Staff Report
City of Richmond, Virginia

Commission of Architectural Review

2. COA-112855-2022	Final Review	Meeting Date: 7/26/2022
Applicant/Petitioner	Mark Baker	
Project Description	Construct a rear addition onto 3 attached dwellings.	
Project Location		
Address: 2511-2515 E. Franklin St.		
Historic District: St. John's Church		
High-Level Details:		
<ul style="list-style-type: none">The applicant requests permission to construct three rear additions on to three masonry row homes circa 1880.The rear additions will be frame, and clad in horizontal cementitious siding.Windows on the rear addition will be vertically aligned 1/1 aluminum clad wood.Rear facade of new addition will have sets of French doors with large single pane windows.The additions will be approximately 24' in length, three stories tall, and will add about 1,000 square feet to each dwelling.No alley exists behind the property, however a public staircase is adjacent to the property. Staff believes that the additions will be visible from this public right-of-way. The rear additions may also be visible from E. Main Street.

Figure 4. Original rear porch design at attached 2509 E. Franklin Street. Simple design with slim square posts and Richmond Rail.

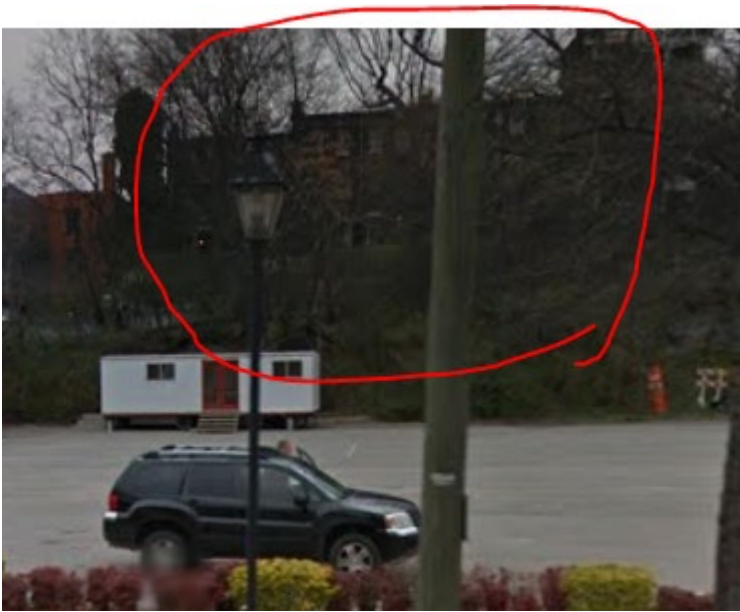
<p>Standards for New Construction, Materials & Colors, pg. 47</p>	<p><i>2. Materials used in new residential construction should be visually compatible with original materials used throughout the district.</i></p> <p><i>3. Paint colors for new additions should complement the historically</i></p>	<p>The proposed rear additions will feature horizontal, hardi plank, lap siding, parged masonry foundation, aluminum clad wood windows, aluminum gutter and downspouts, TPO Membrane roofing, solid wood doors, hardi trim, wooden decking.</p> <p>Gutters and downspouts will be aluminum. <u>Staff recommends that either half round or box getters be utilized on the rear additions. final specifications submitted to staff for review and approval.</u></p> <p>The applicant is requesting permission to install nailed-up-pickets on the rear handrails of the proposed additions' decks. There is not a precedent for approving nailed-up-pickets within City Old and Historic Districts, and they are not compatible with historic railing designs throughout the district. <u>Staff recommends that the rear decks feature Richmond Rail and a finished appearance with no exposed hardware or a simple contemporary railing rather than nailed-up pickets.</u></p>
